PIG ATE MY PIZZA

STORMWATER MANAGEMENT REPORT

City Review

ARC24021

Pond UI1: UNDERGROUND INFILTRATION - Chamber Wizard Field A

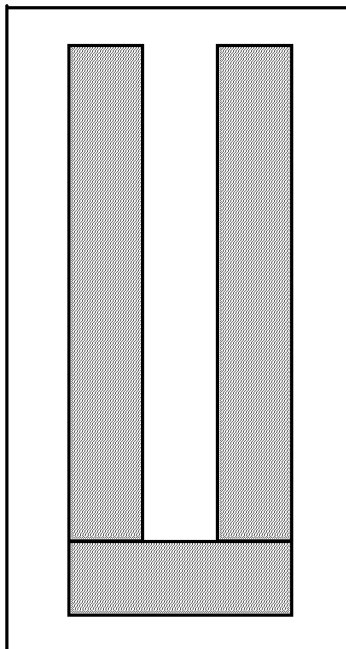
Drawdown time needs to be 48 hours, adjust design to meet requirement

Provide soil boring from within proposed stormwater BMP to confirm proposed infiltration rate and 3 feet of separation from groundwater.

Stormwater infiltration BMP must not mobilize contaminants in soil or groundwater. Given past history of site as a gas station address any known contaminants and prevent mobilizing contaminants with stormwater infiltration. See the Minnesota Stormwater manual for guidance on infiltration BMP's on contaminated sites.
